COUNCIL OFFICERS' REPORTS

Memorandum

SUBJECT: **LUC-2016-384, REMOVAL OF VEGETATION FROM PIPELINE, 58 NAIRN STREET, 25 LYNN ST.. COMMENT FROM LANDSCAPE ARCHITECT.**

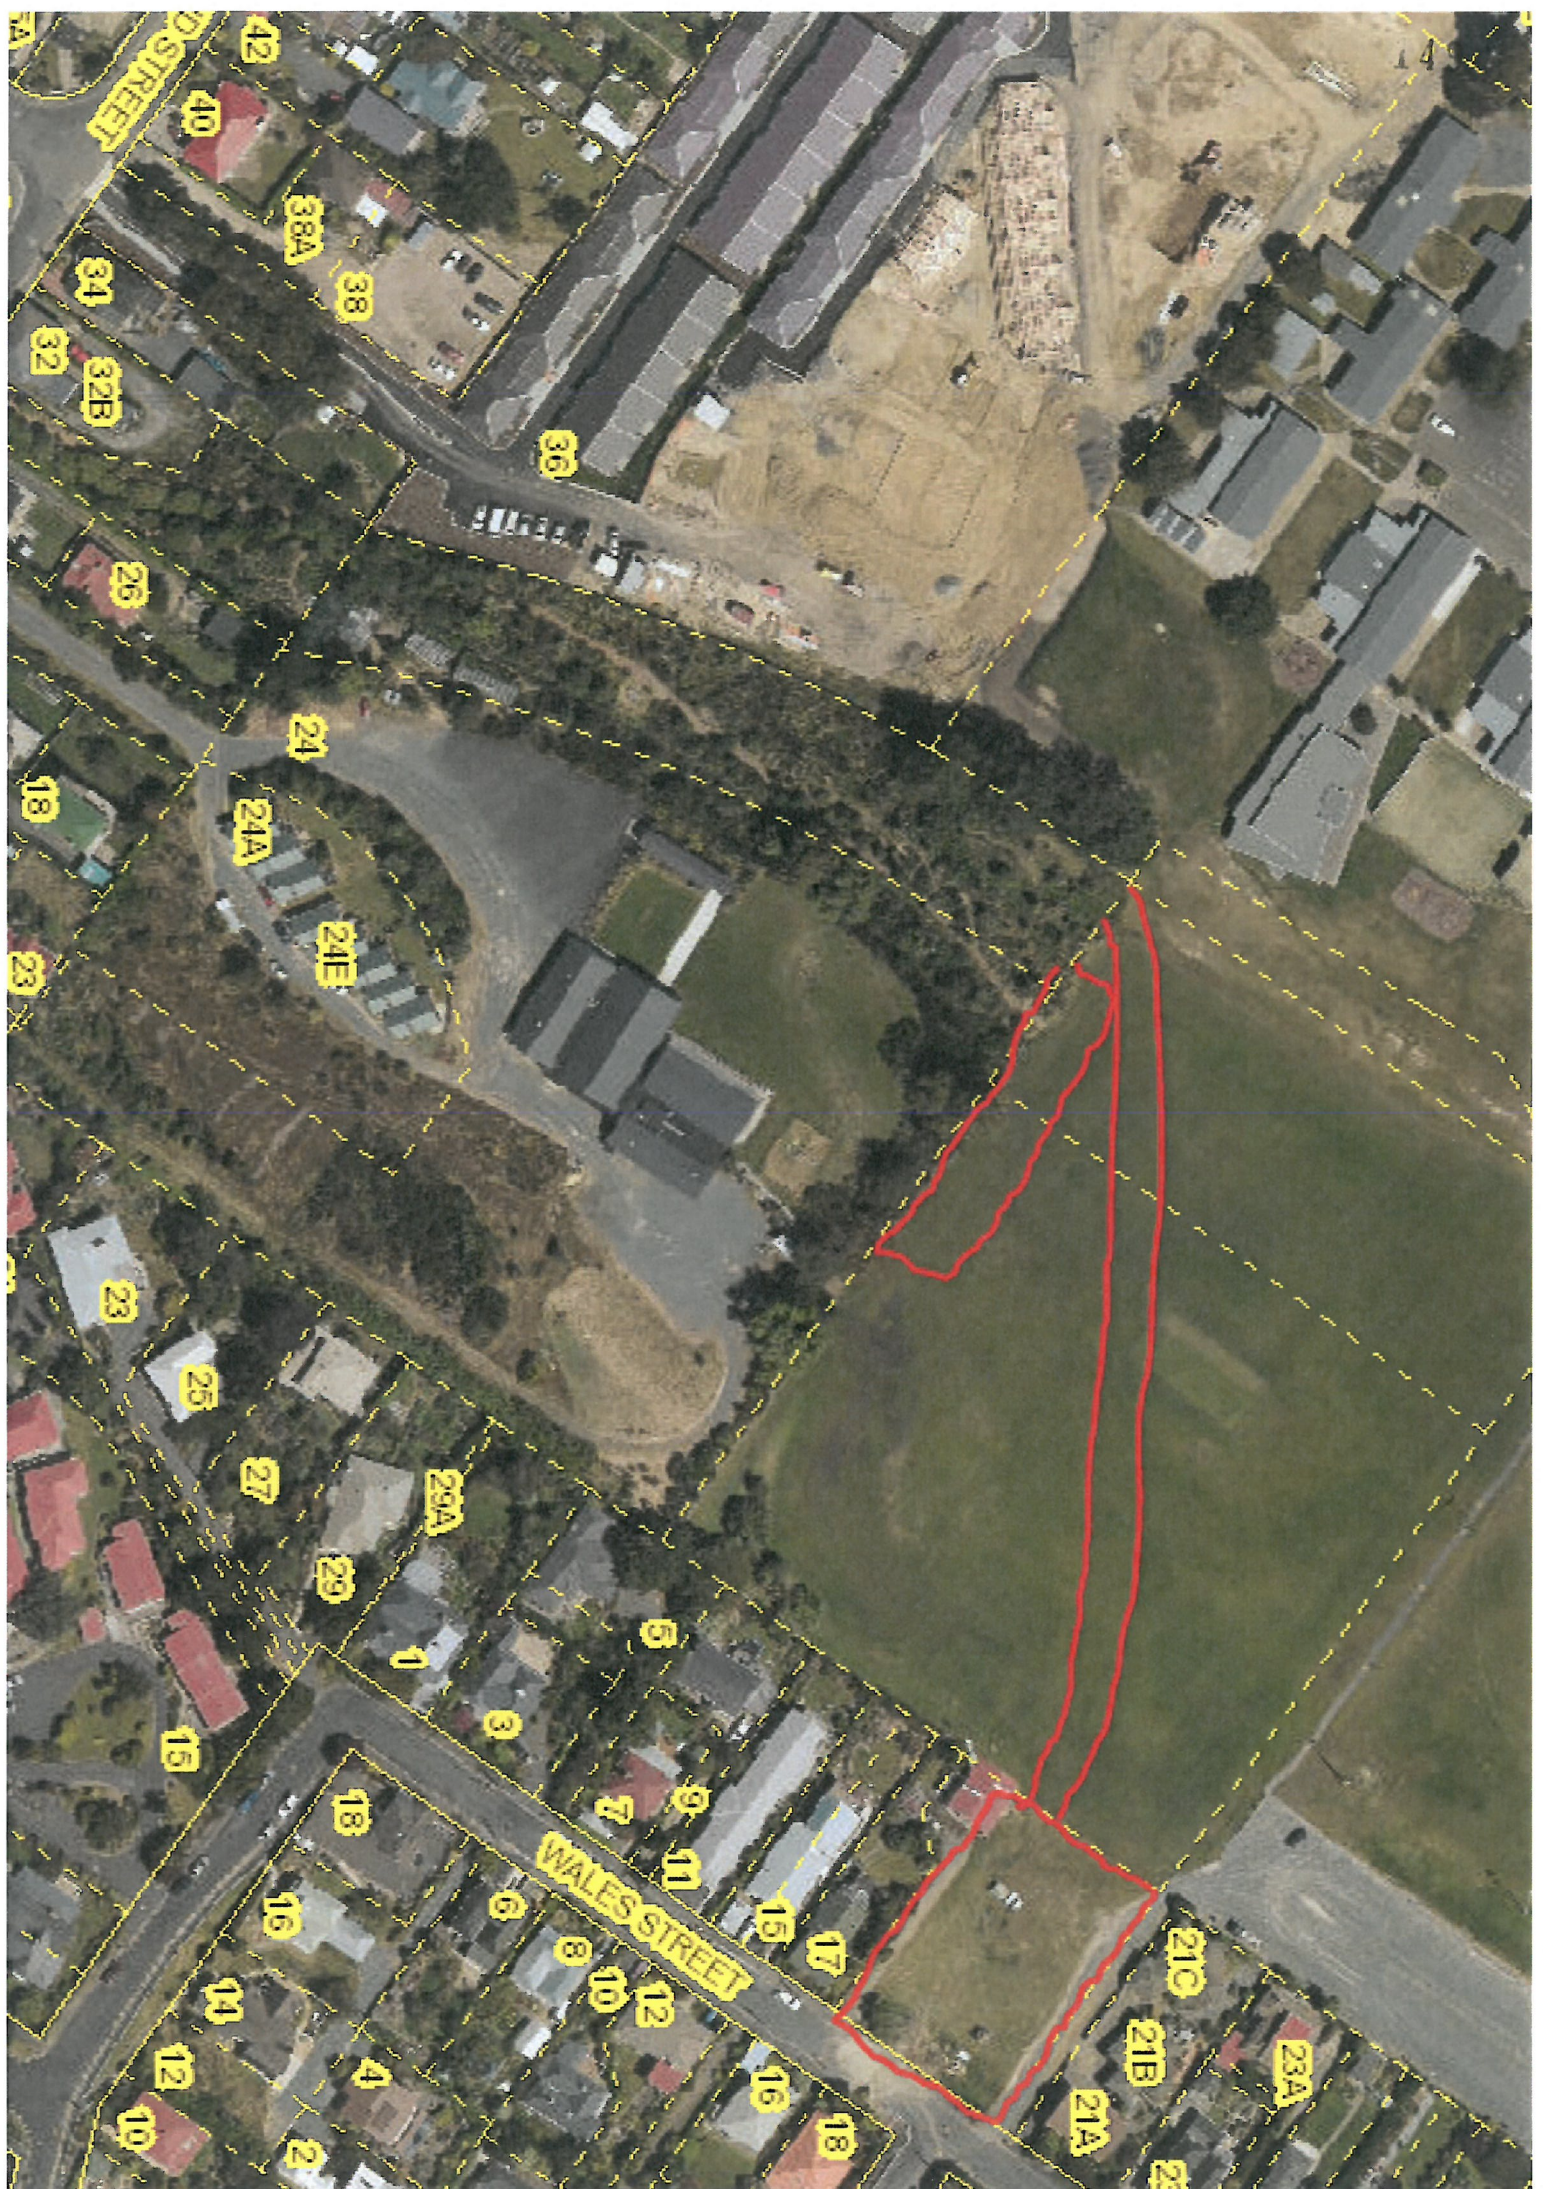
Three sites are being used to storage of plants during the project. For the area between School and Shetland Street, trees will be stored inground at DCC-owned vacant lot at 56 School Street, and in the large grassy area near the wetland area (Please see attached **map 1**). These areas will be fenced off from the public during the duration of the project, and will be put back into grass, or further developed as part of the commons after use as storage.

Storage of uplifted trees and shrubs from the area between Shetland Street and Bishops court Sports ground is proposed to be sited in a strip at the end of the Sportsfield (Please see attached map 2). This area will be fully fenced off from the public.

The Wale Street site is currently proposed as a depot site for contractors (Please see attached **map 2**). This site is the only available access for the works to be carried out. If the Wale street site is not able to be used as a depot it is possible that an area of the sportsfield could be fenced off and made secure for use. Please note that this is a proposal only at this stage.
